**SHEARON HARRIS NUCLEAR POWER PLANT, UNITS 2 AND 3  
DOCKET NOS. 52-022 AND 52-023  
SUPPLEMENT 1 TO RESPONSE TO REQUEST FOR ADDITIONAL INFORMATION LETTER  
NO. 010 RELATED TO GROUNDWATER**

**Shearon Harris Nuclear Power Plant Units 2 and 3  
Supplement 1 to Response to NRC Request for Additional Information Letter No. 010  
Related to SRP Section 02.04.12 for the Combined License Application,  
dated September 18, 2008**

**NRC RAI #:** 02.04.12-2

Progress Energy Carolinas  
**Shearon Harris Nuclear Power Plant  
 Units 2 and 3**  
 New Hill, North Carolina  
 Site Drainage Map and Impervious Areas  
 (Post-construction)  
**FIGURE 1**

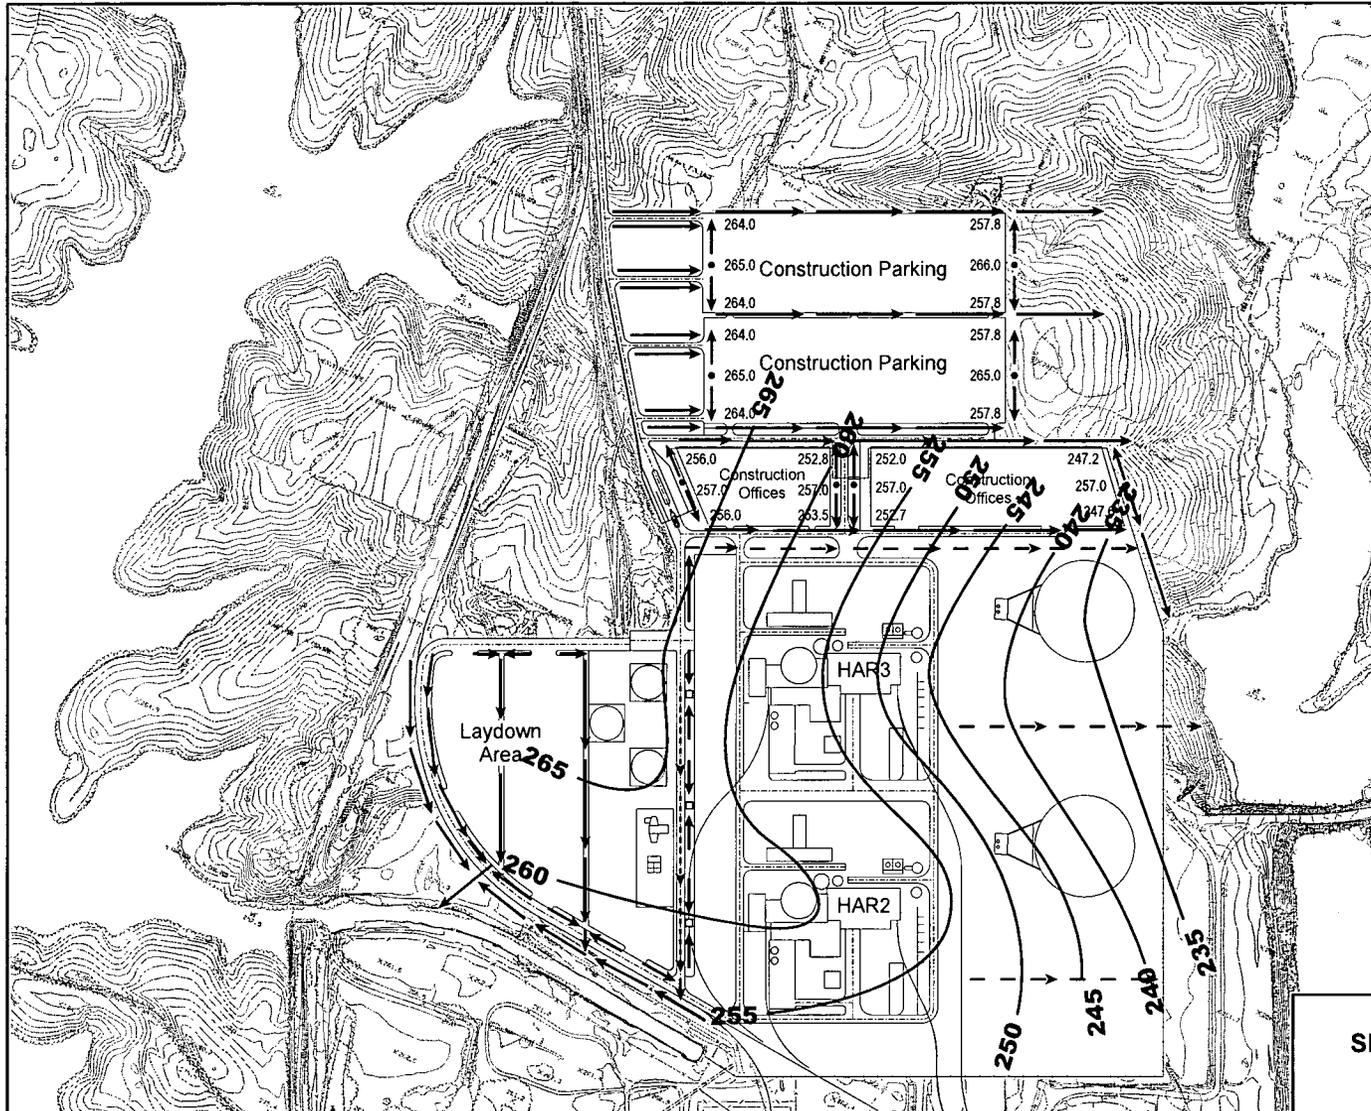
Describe the impact that the changes in site conditions will have on the post-construction piezometric heads and provide sufficient detail to support this impact. Some of these changes may result in a decrease the piezometric head elevation relative to current conditions and other factors may result in increase in the piezometric head elevation. The factors that could result in changes to the piezometric head include (but are not restricted to) the following: increase in Main Reservoir pool elevation, site grading, backfill, stormwater drains, and changes in recharge.

- 3) Increase in impervious surface area: Figure 1 illustrates proposed impervious areas of the developed site. The developed area of the HAR site will be approximately 178 acres, with about 55 acres of this area being impervious. Therefore, approximately 31 percent of the total HAR site area will be impervious to recharge. Figure 1 also shows the safety-related drainage area as defined by the dashed line. Of this area (approximately 111 acres), about 51 acres or 46 percent will be impervious. These impervious surfaces will eliminate direct recharge in those areas and, therefore, significantly reduce the potential for localized groundwater mounding beneath the safety-related structures.
